Access Compliance Report

Public Rights-of-Way

(Curb Ramps)

Intersection ID: 7786	Main Street: EAGLES_LANDING_DR	Cross Street: NESTING_CT	Location:	N
ADA ID: 4F9E9D48BD04	Ramp Type: BlendTrans2	Initial Pass/Fail: Fail	Overall Compliance: No	Severity Score: 1.25

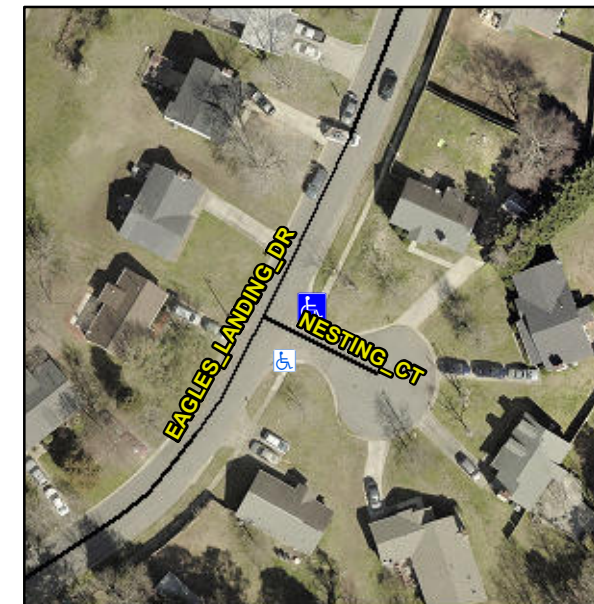
R304.5.3

Compliance	Description	Data	Compliance	Description	Data
N/A	Ramp Length (in)	107.0	Yes	BlendTrans Slope (%)	2.2
Yes	Ramp Width (in)	50.0	No	BlendTrans XSlope (%)	2.2
N/A	Flare Type LT	N/A	N/A	Flare Type RT	N/A
N/A	Flare Slope LT (%)	N/A	N/A	Flare Slope RT (%)	N/A
N/A	Flare Traversable LT?	N/A	N/A	Flare Traversable RT?	N/A
N/A	Landing Length (in)	N/A	N/A	DWS Provided?	N/A
N/A	Landing Width (in)	N/A	N/A	DWS Contrast?	N/A
N/A	Landing Slope (%)	N/A	N/A	DWS Length (in)	N/A
N/A	Landing X Slope (%)	N/A	N/A	DWS Full Width?	N/A
N/A	Landing Curb? (Y/N)	N/A	N/A	DWS Offset (in)	N/A
N/A	Shared Landing?	N/A			
N/A	Gutter Ponding?	N/A	N/A	Gutter Slope (%)	N/A
N/A	Gutter Lip Ht (in)	N/A	N/A	Gutter X Slope (%)	N/A
N/A	Painted X Walk1?	No	N/A	Painted X Walk2?	N/A
	X Walk 1 Direction	To SW		X Walk 2 Direction	N/A
	X Walk 1 Width (in)	N/A		X Walk 2 Width (in)	N/A
	X Walk 1 Slope (%)	1.0		X Walk 2 Slope (%)	N/A
	X Walk 1 X Slope (%)	0.9		X Walk 2 X Slope (%)	N/A

Remove & Replace Curb Ramp With Two New Directional Ramps or Equivalent.
